CROSS SECTIONS

REVISED NDC02	STATE VA.	ROUTE 621	STATE PROJECT 6234-076-266, C-501, RW-201	SHEET NO. X178
------------------	--------------	--------------	--	-------------------

Ramp 1A

REVISED NDC02	STATE VA.	ROUTE 234	STATE PROJECT 6234-076-266, C-501, RW-201	SHEET NO. X357
------------------	--------------	--------------	--	-------------------

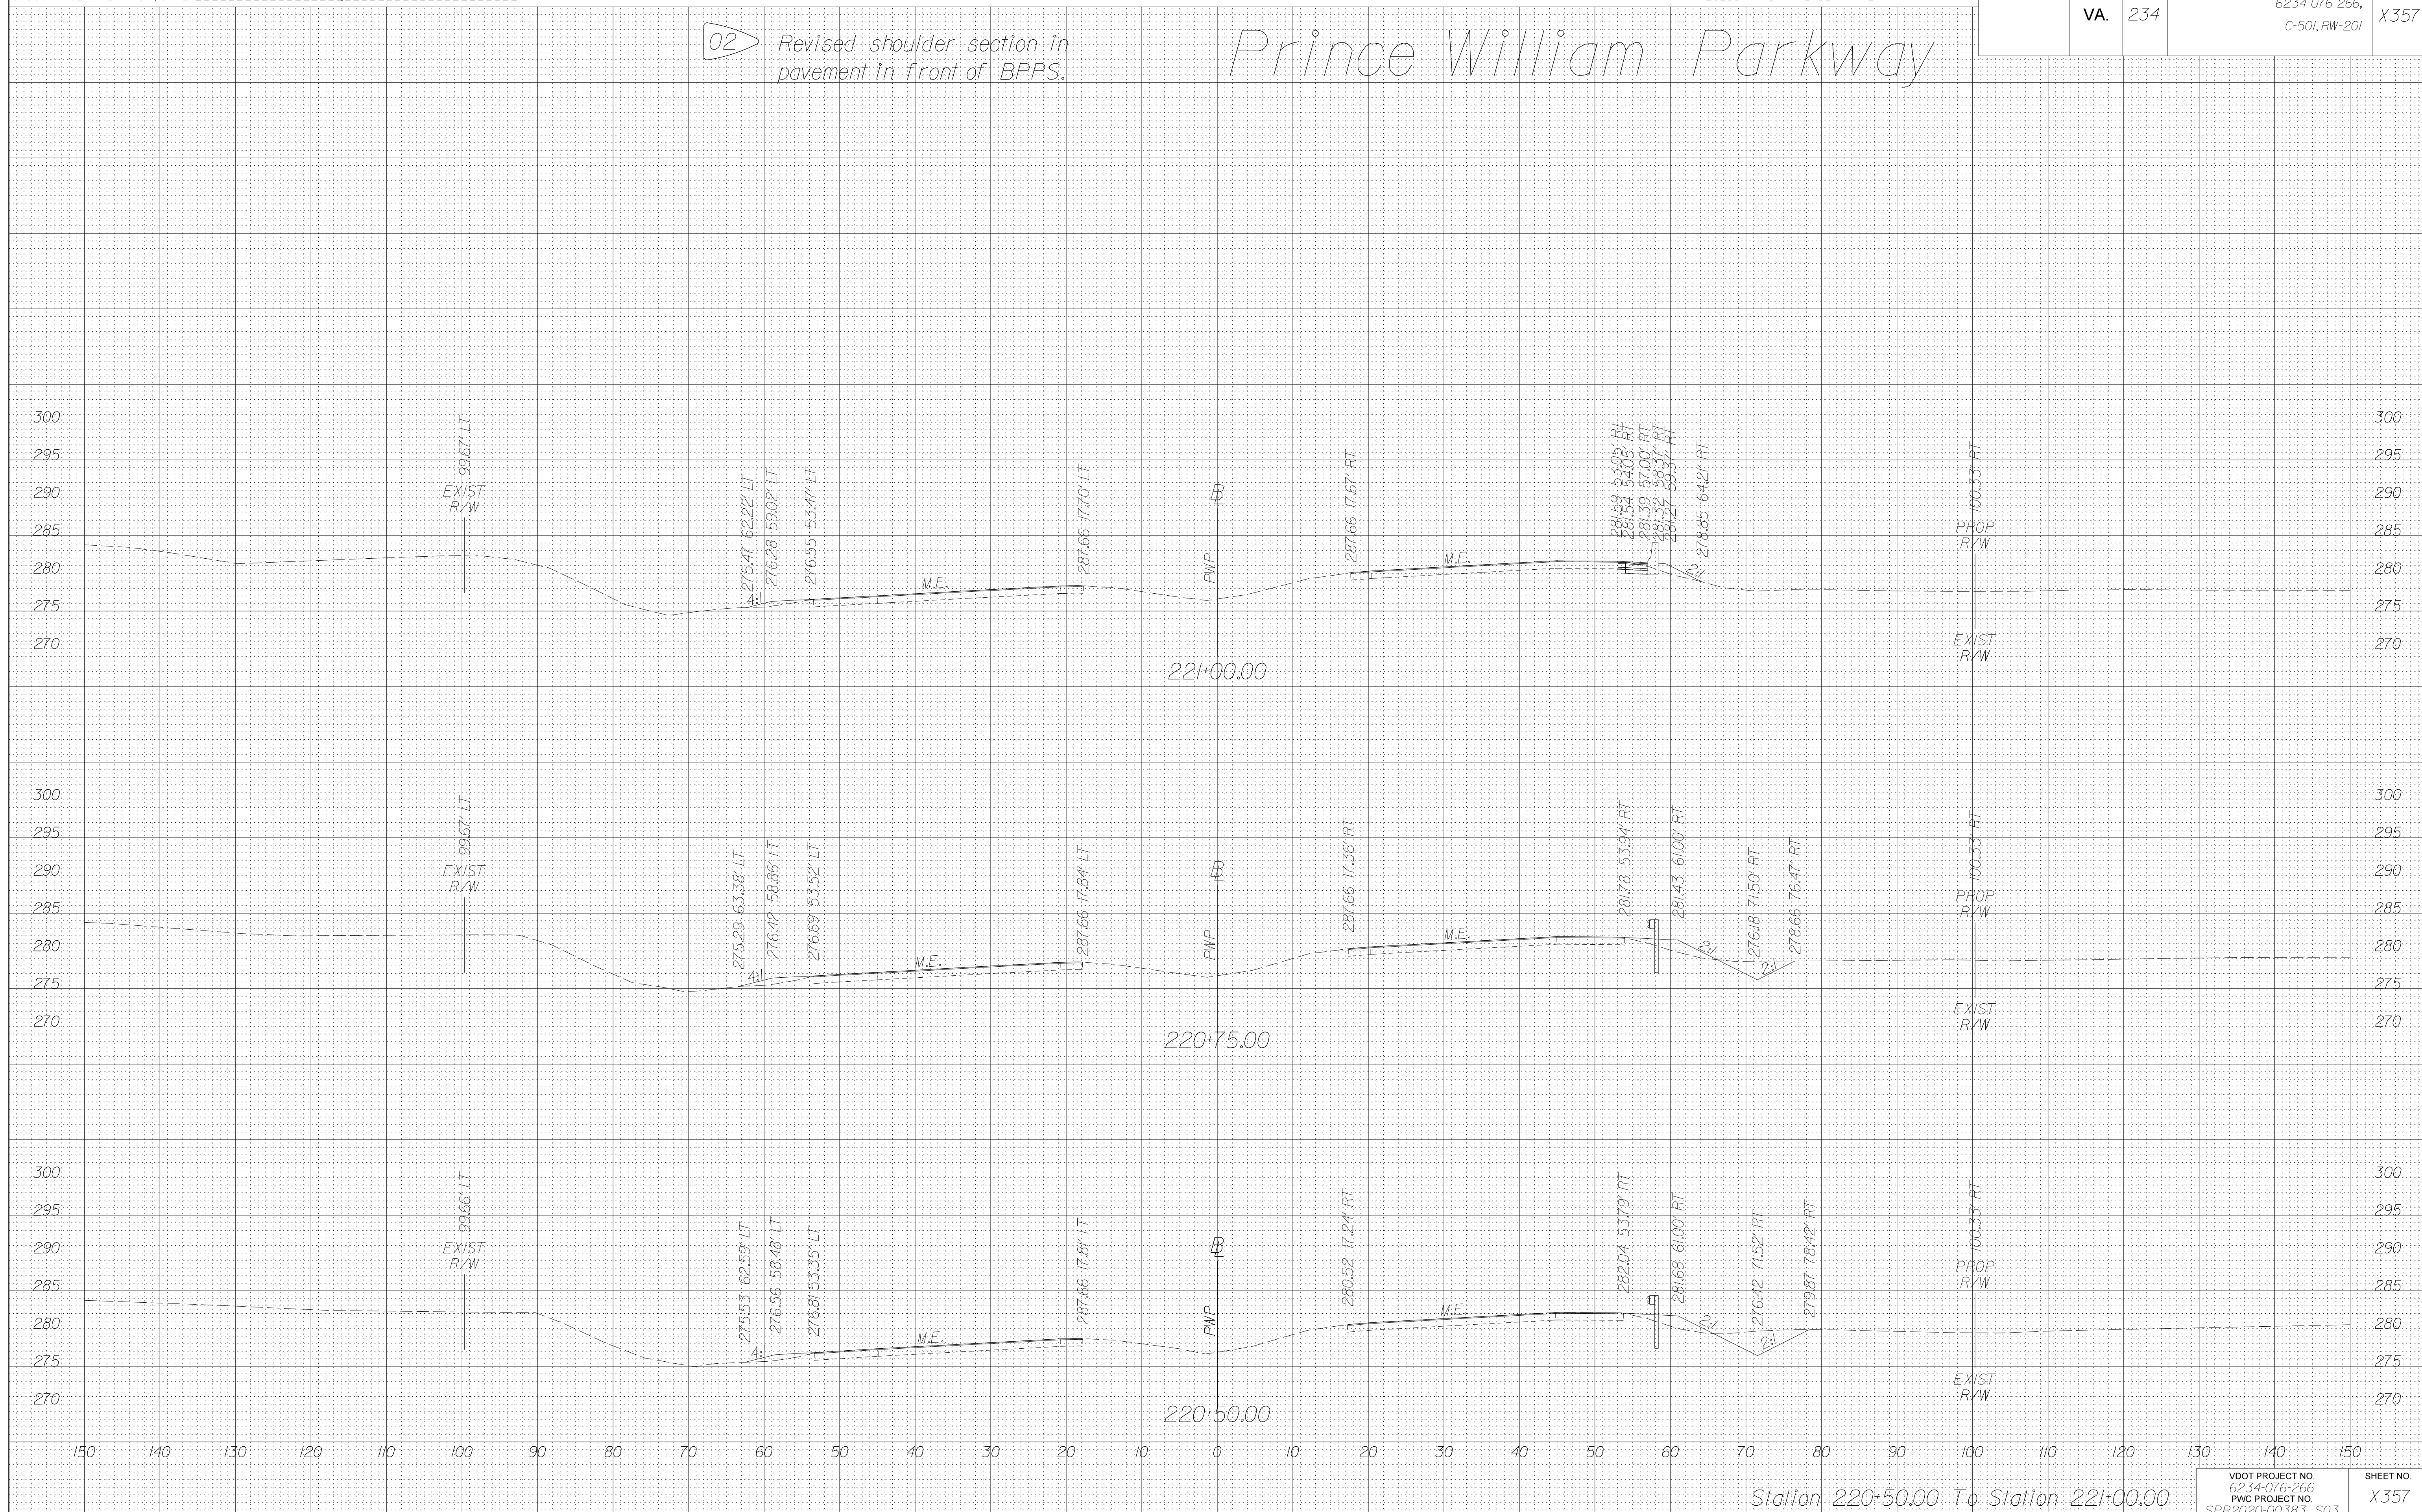
02 Revised shoulder section in pavement in front of BPPS.

REVISED NDC02	STATE VA.	ROUTE 234	STATE PROJECT 6234-076-266, C-501, RW-201	SHEET NO. X360
------------------	--------------	--------------	--	-------------------

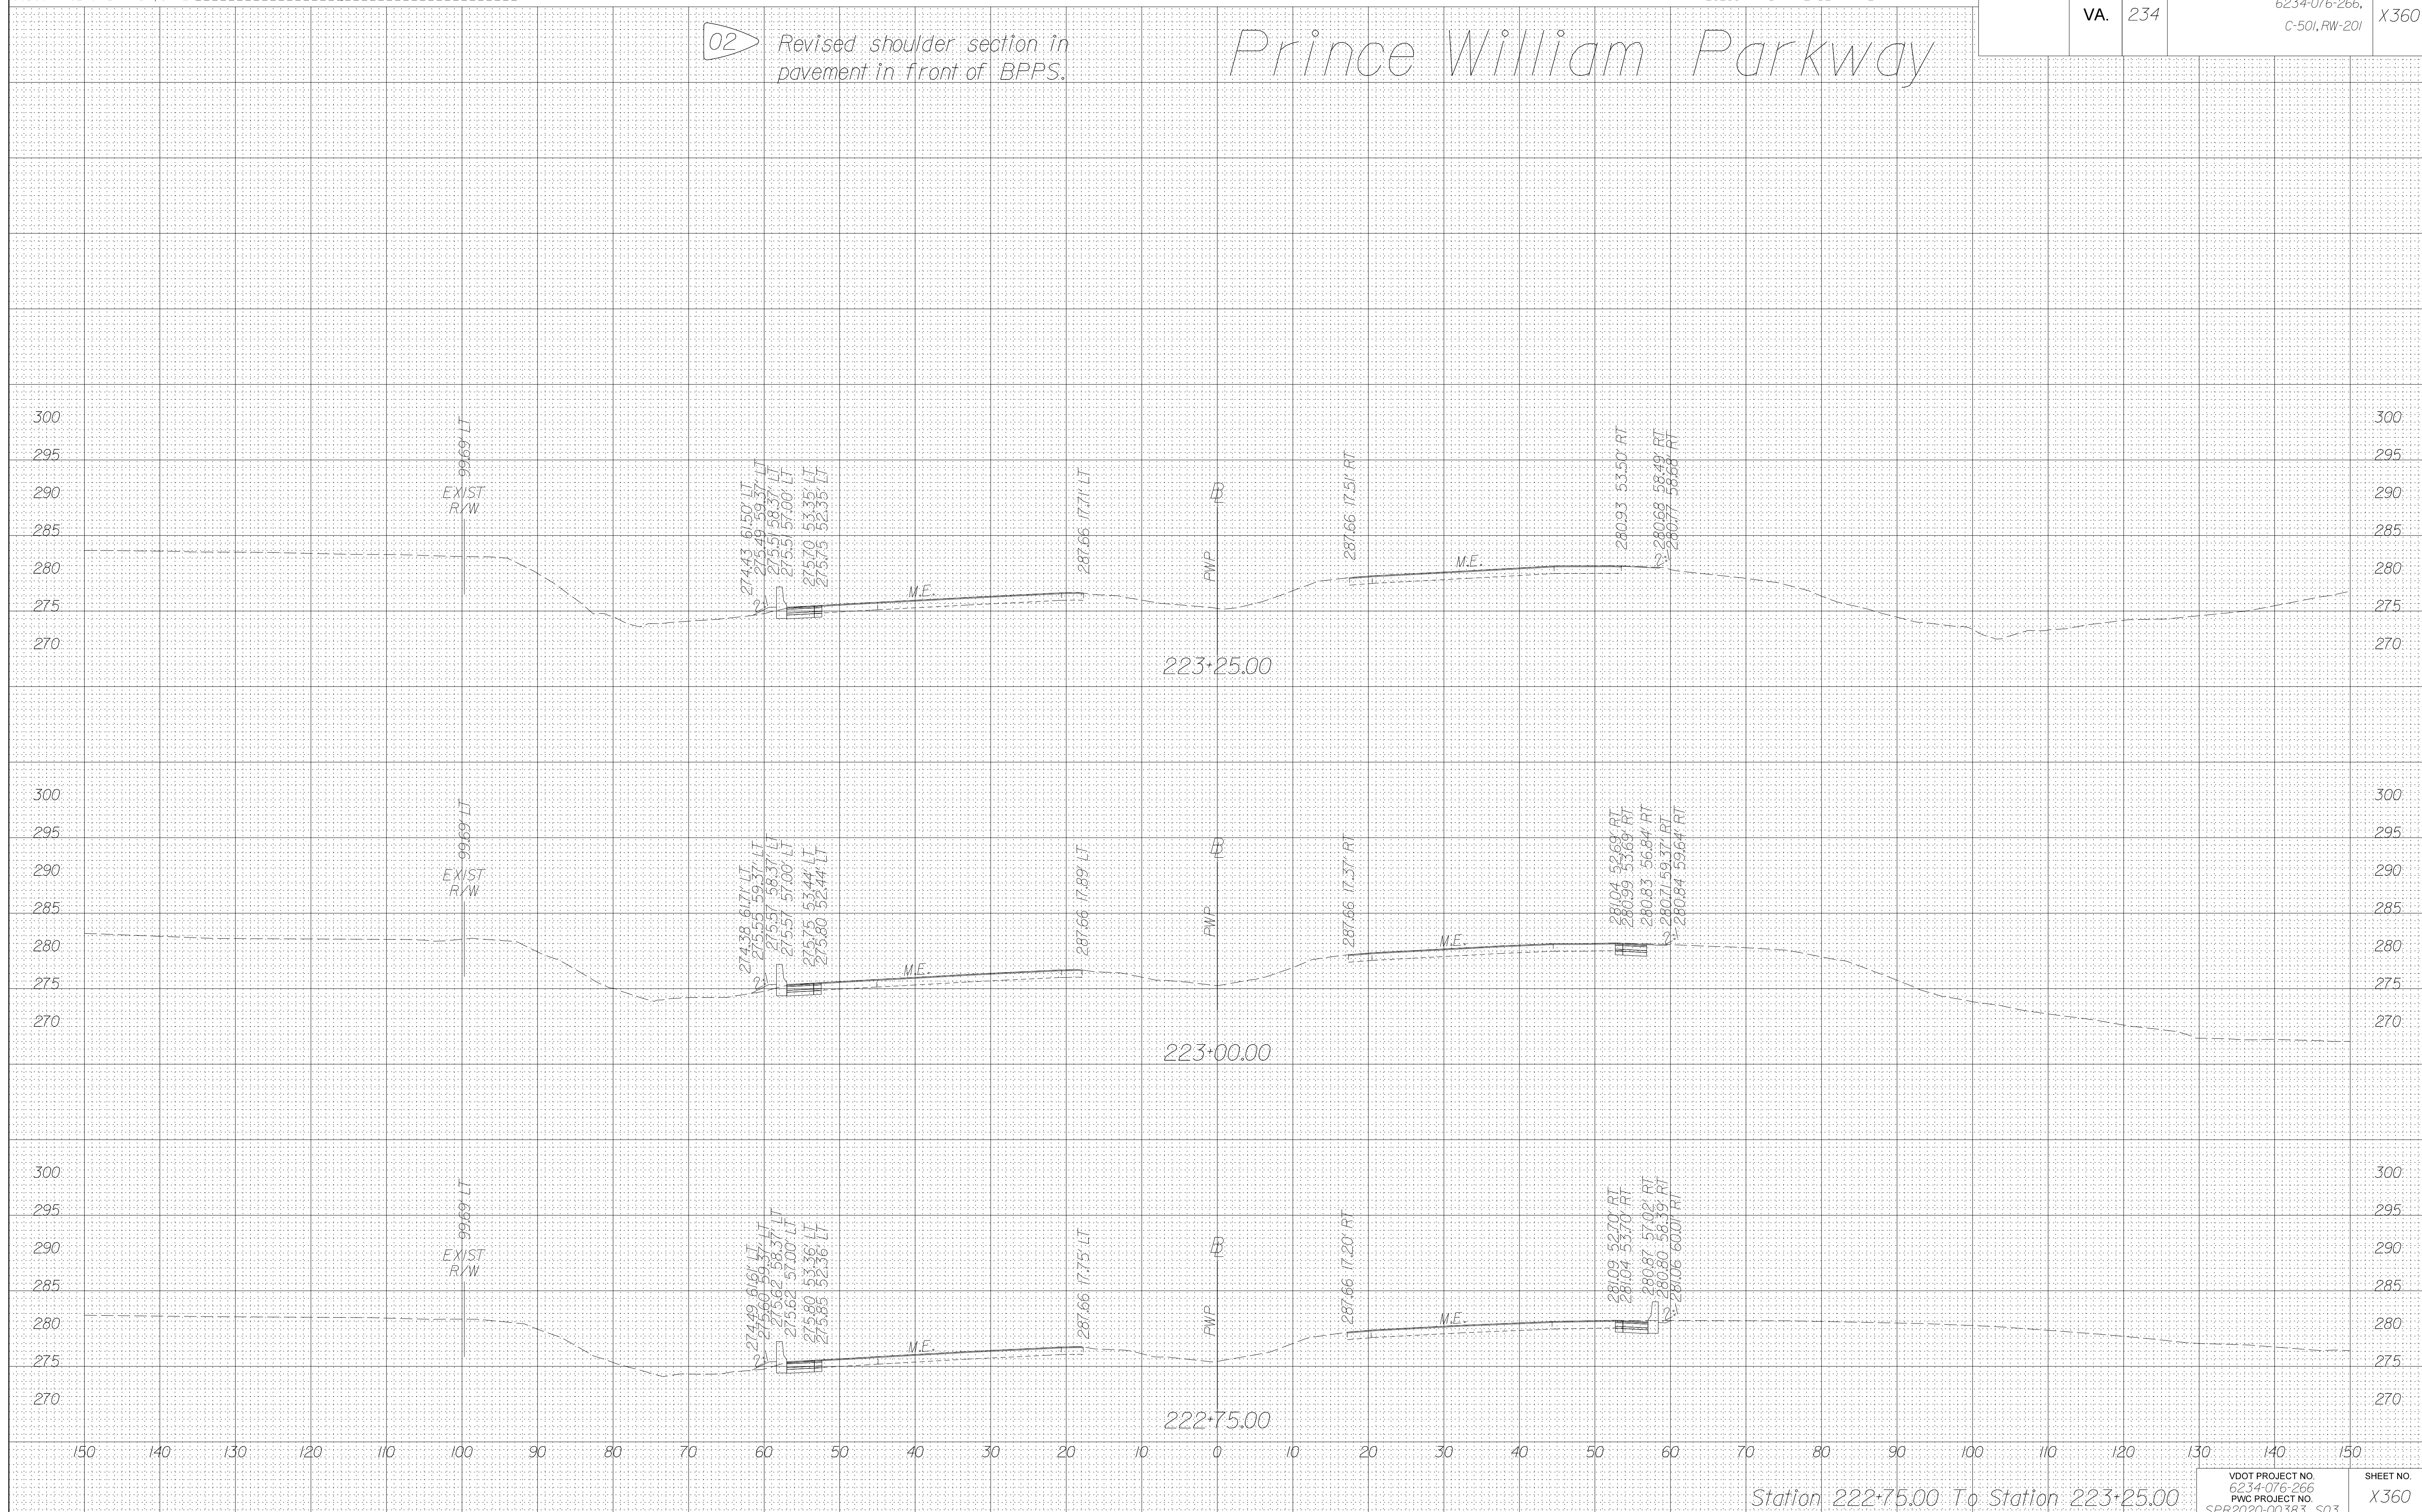
02 Revised shoulder section in pavement in front of BPPS.

REVISED NDC02	STATE VA.	ROUTE 234	STATE PROJECT 6234-076-266, C-501, RW-201	SHEET NO. X361
------------------	--------------	--------------	--	-------------------

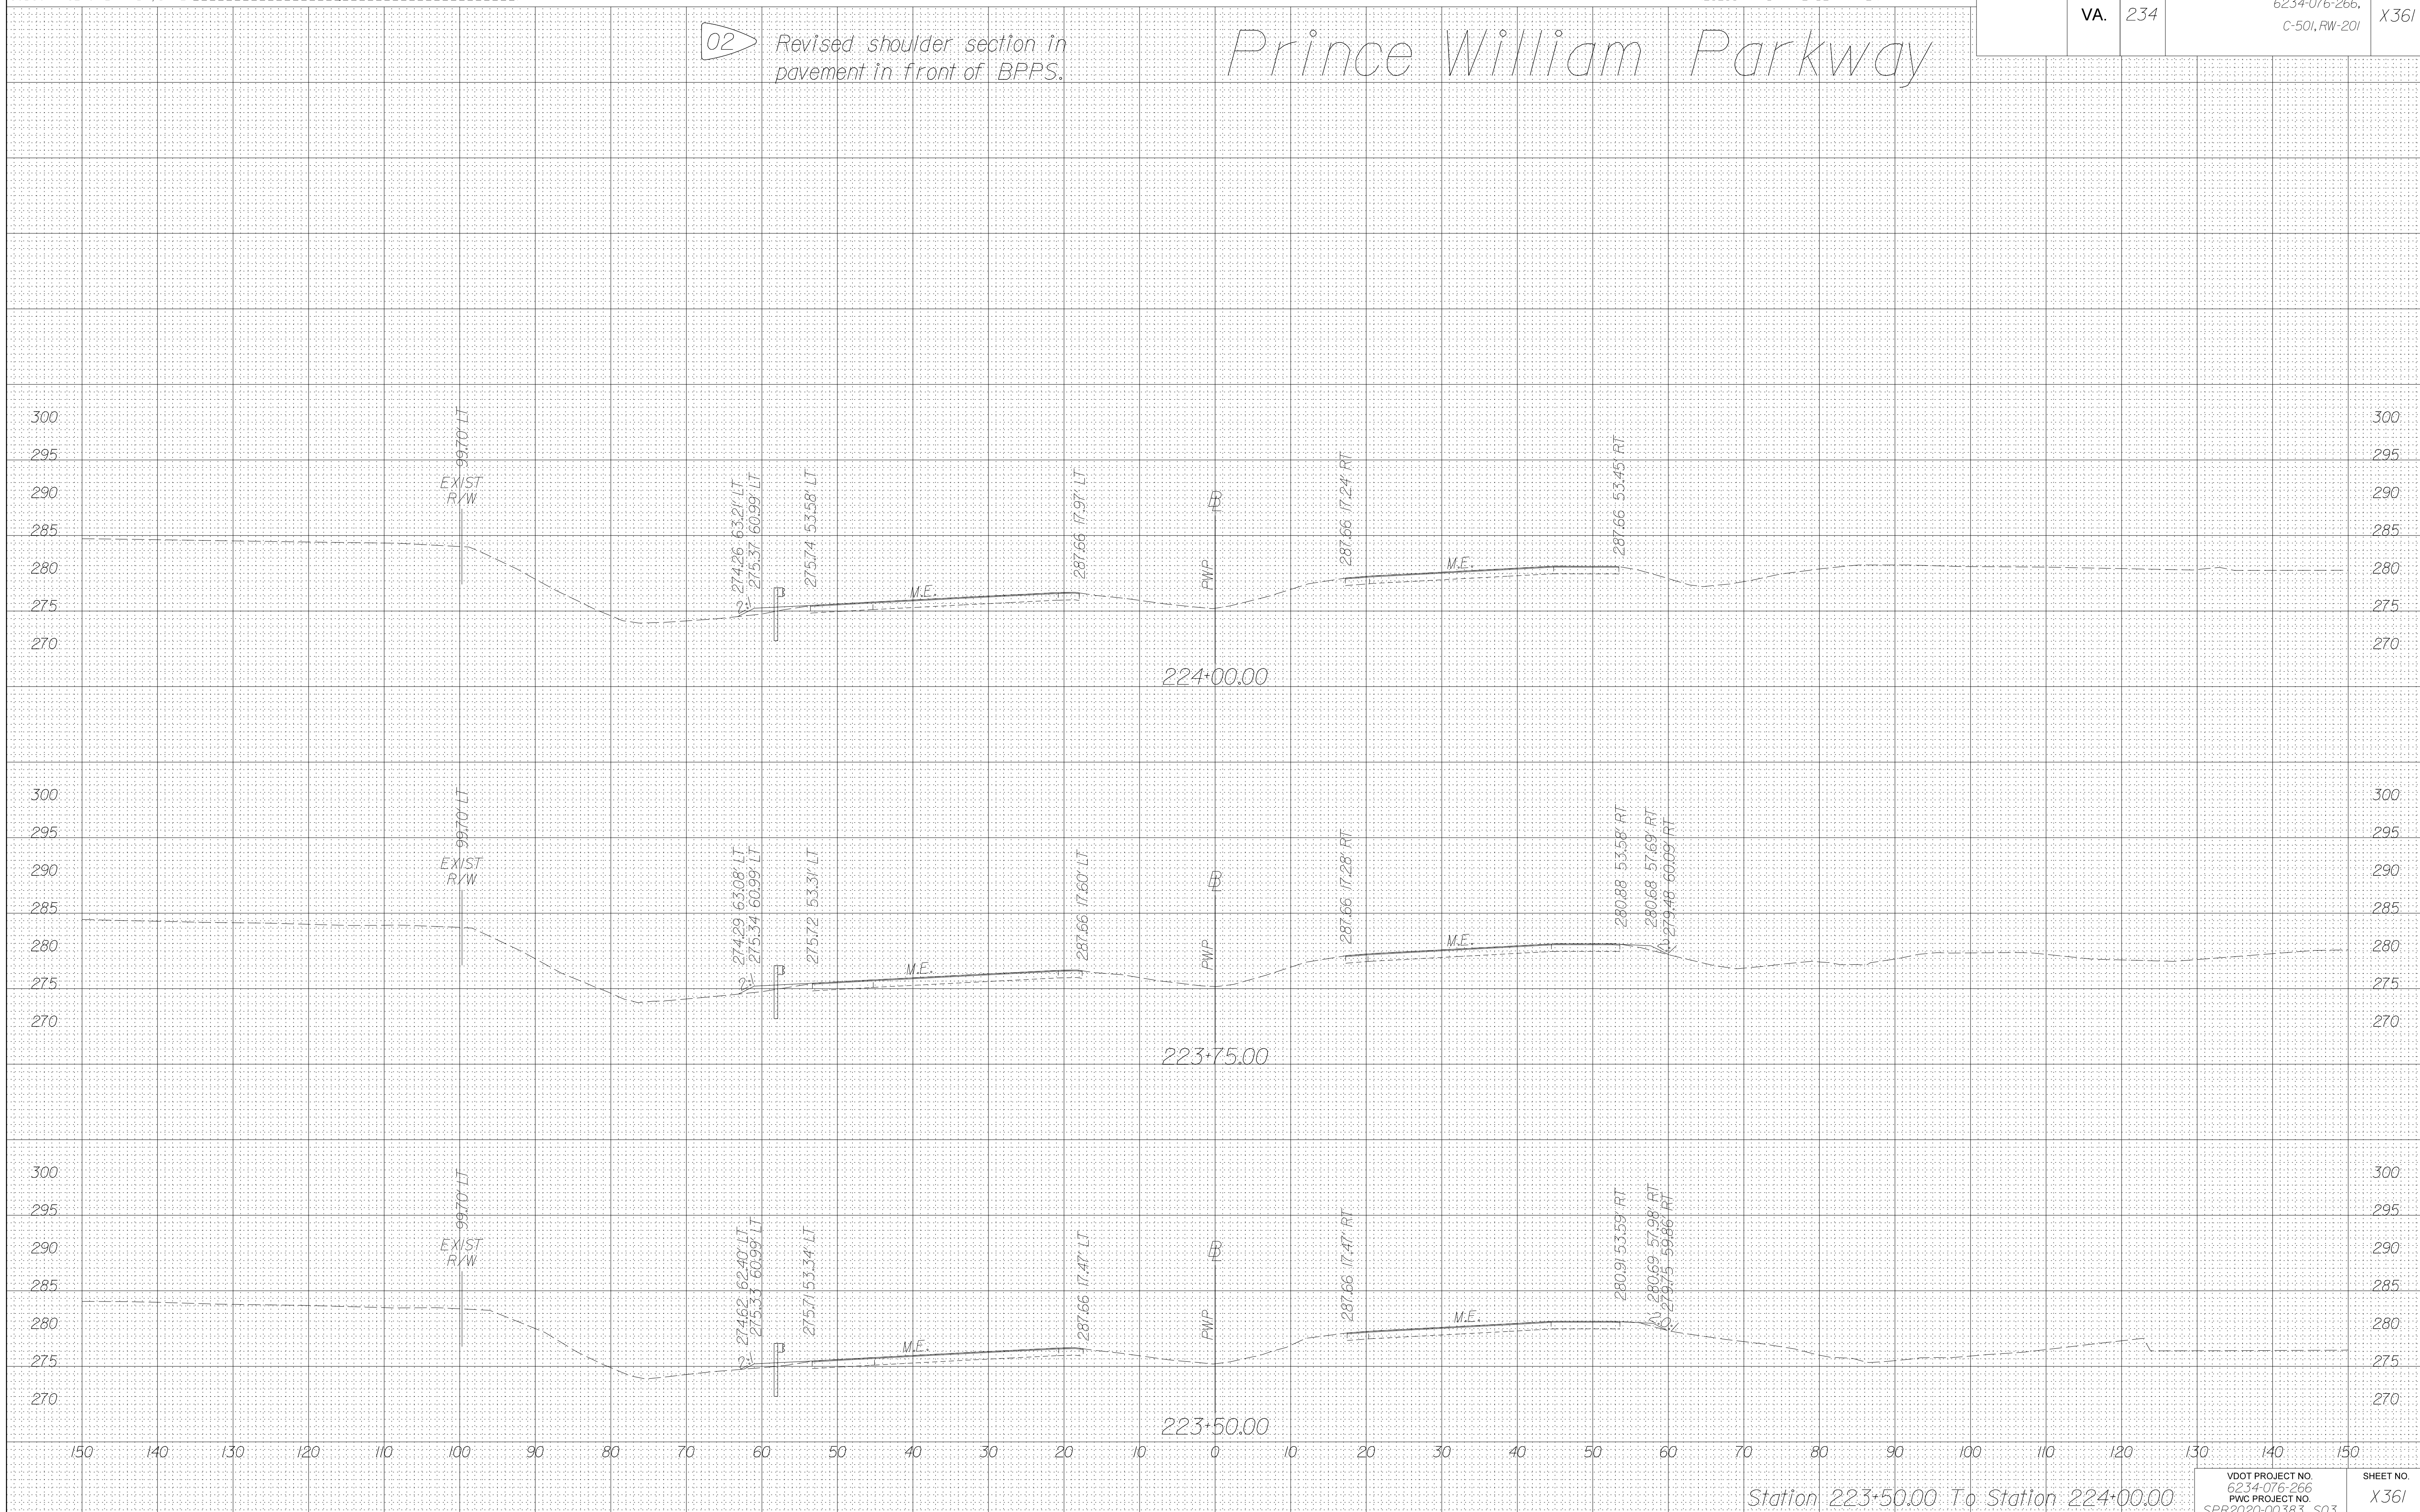
02 Revised shoulder section in pavement in front of BPPS.
